**RE: Revision of blocking between floor joists under kitchen island for Lot #1 Cobey Creek –504 SE David Rd.  
Lee's Summit, MO 64082 – Permit # PRRES20215762**

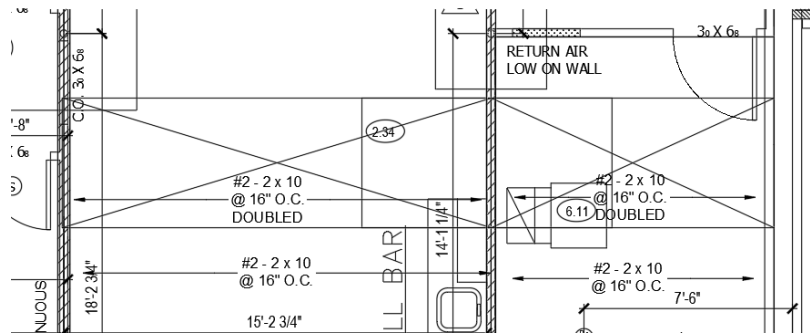
**Recommended modifications:**

- Floor joists shall be Douglas Fir Larch #2 2x10 doubled as shown in image above.
- Install 2x4 blocking at 48" oc under kitchen island.
